UNITED STATES PATENT AND TRADEMARK OFFICE

APPLICATION NO.	FILING DATE	FIRST NAMED INVENTOR	ATTORNEY DOCKET NO.	CONFIRMATION NO.
09/681,674	05/18/2001	Yoshifumi Natsuyama	JP920000096US1	3666
877	7590	06/16/2004	EXAMINER	
IBM CORPORATION, T.J. WATSON RESEARCH CENTER P.O. BOX 218 YORKTOWN HEIGHTS, NY 10598			RUDE, TIMOTHY L	
			ART UNIT	PAPER NUMBER
			2871

Office Action Summary	Application No. 09/681,674	Applicant(s) NATSUYAMA, YOSHIFUMI	
	Examiner Timothy L Rude	Art Unit 2871

DETAILED ACTION

Figure 11

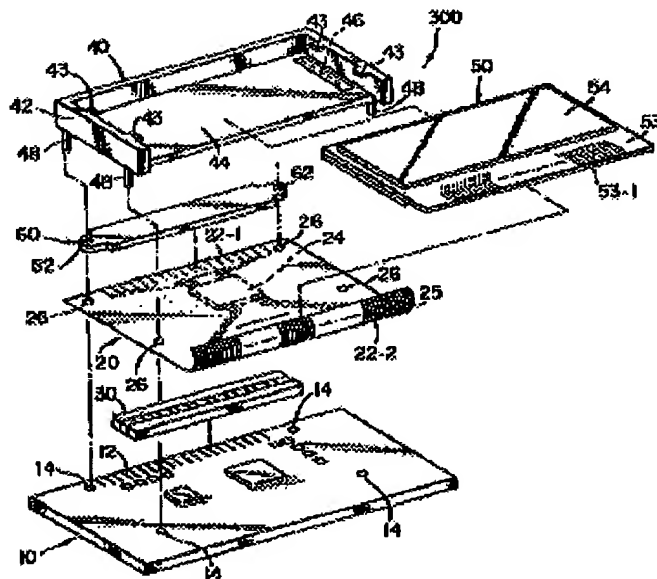
As to claim 4, Muramatsu discloses in his third embodiment, [Figures 11 and 12, col. 10 line 66 through col. 13, line 6] a liquid crystal display device, 50, comprising: a pair of glass substrates facing each other, each having electrodes for applying voltage to a liquid crystal material on a facing surface (typical); a circuit board, 10, for supplying said voltage; and a liquid crystal driver tape carrier package, [20, col. 11, lines 7-9 and col. 7, lines 1-3] for connecting said electrodes of said glass substrates to said circuit board and mounting a liquid crystal driver chip [col. 11, lines 7-9 and col. 7, lines 4-13], wherein said liquid crystal driver tape carrier package and said circuit board anchor

As to claim 6, Muramatsu discloses the liquid crystal display device wherein a pair of said anchor holes, 26, is located with said liquid crystal driver chip, 24, between [diagonally per Figure 11].
